**From:** Steve Christensen  
**To:** Daron Haddock; Jim Smith; John Gefferth; OGMCOAL  
**Date:** 3/3/2008 10:36 AM  
**Subject:** Emery Deep (C/015/0015): Conditional Approval Letters  
**Place:** OGMCOAL  
**Attachments:** 0056.pdf; 0048.pdf

Subject: Status of Full Extraction Pillar Splitting Conditions for 60-Day Increment Conditional Approval for 15<sup>th</sup> West and Zero North and Deficiency List for 15<sup>th</sup> West, 4<sup>th</sup> East, 6<sup>th</sup> Est and Zero North Panels, Consolidation Coal Company, Emery Deep Mine, C/015/0015, Task #2821, Outgoing File

### PHC Update and Full Extraction Pillar Splitting – 15<sup>th</sup> West, 4<sup>th</sup> East, 6<sup>th</sup> East and Zero North Panels

Subject: Full Extraction Pillar Splitting - 14<sup>th</sup> West Panel - Conditional Approval,  
Consolidation Coal Company, Emery Deep Mine, C/015/0015

FIGURE 2. EMERY MINE 15th WEST PANEL  
 FULL EXTRACTION PLAN

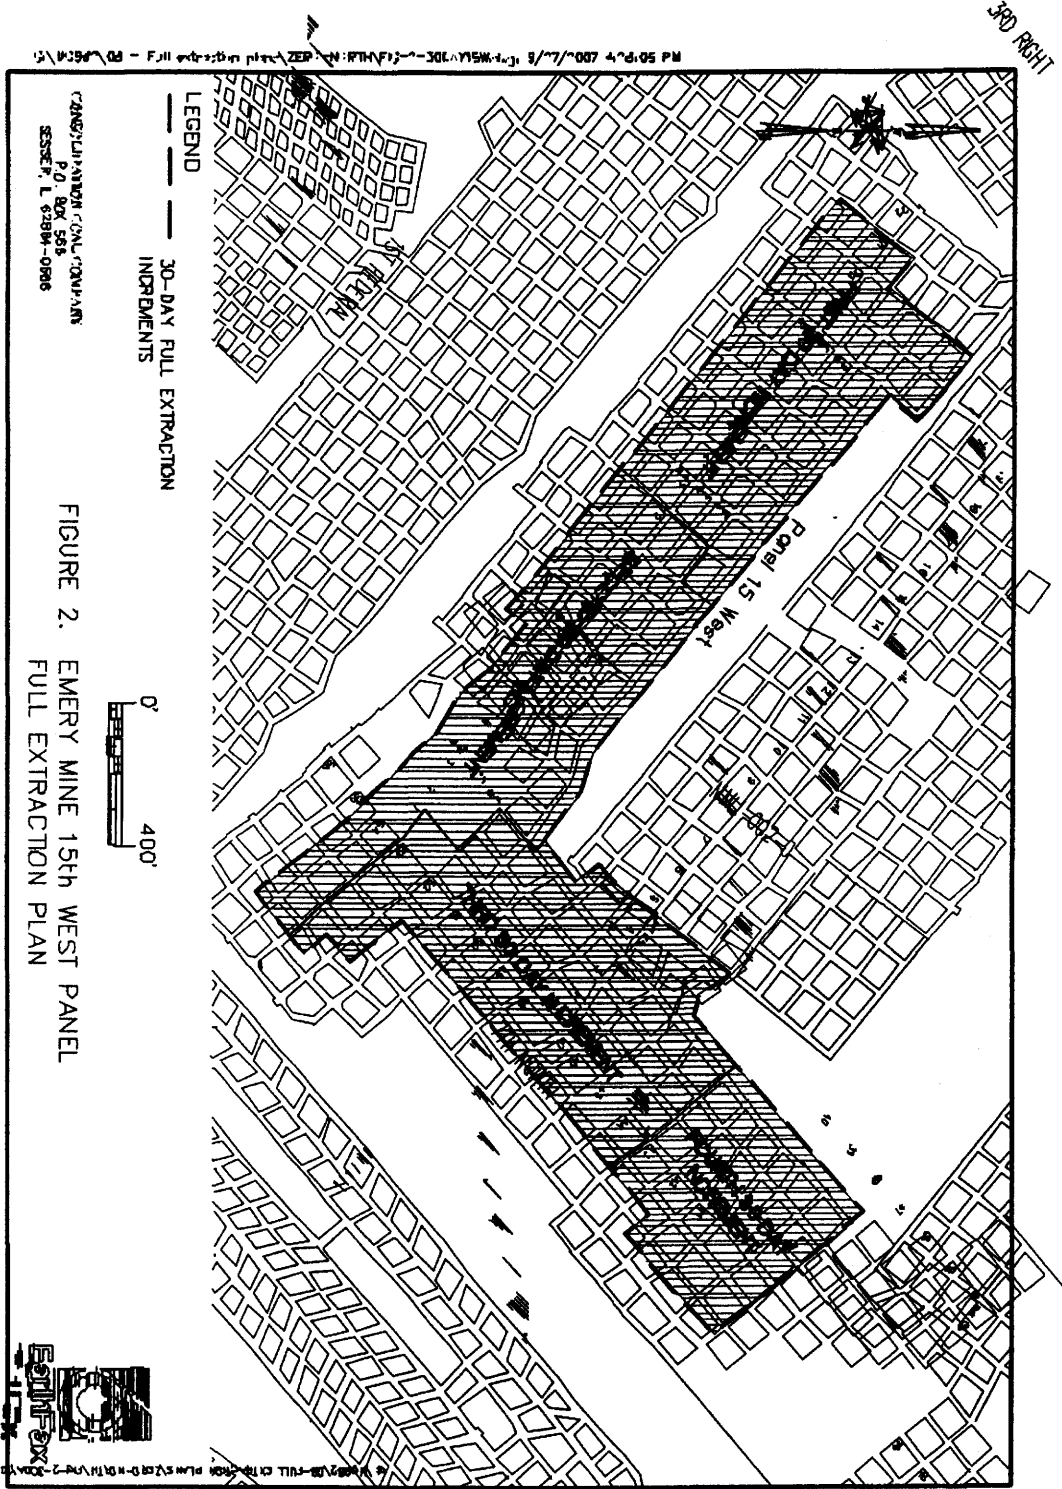
The Division hereby approves full extraction pillar splitting as shown for the first 30-day increment in the attached map with the following conditions:

By April 20, 2007, Consol will submit the entire 14<sup>th</sup> West full extraction plan. This revised application will contain the required wildlife and vegetation information that is currently being finalized by Consol's consultant.

By July 2, 2007, (or another date as negotiated by the Division and Consol), Consol will submit an updated Probable Hydrologic Consequence (PHC). This PHC update will include but not be limited to updated potentiometric hydraulic surface maps and an analysis of the well data and the effects of previous mining on the ground water and the future effect of full extraction on the aquifer.

By July 2, 2007, Consol will resubmit an application for the remainder of the three areas for full extraction (15<sup>th</sup> West, 4<sup>th</sup> East, 6<sup>th</sup> West).
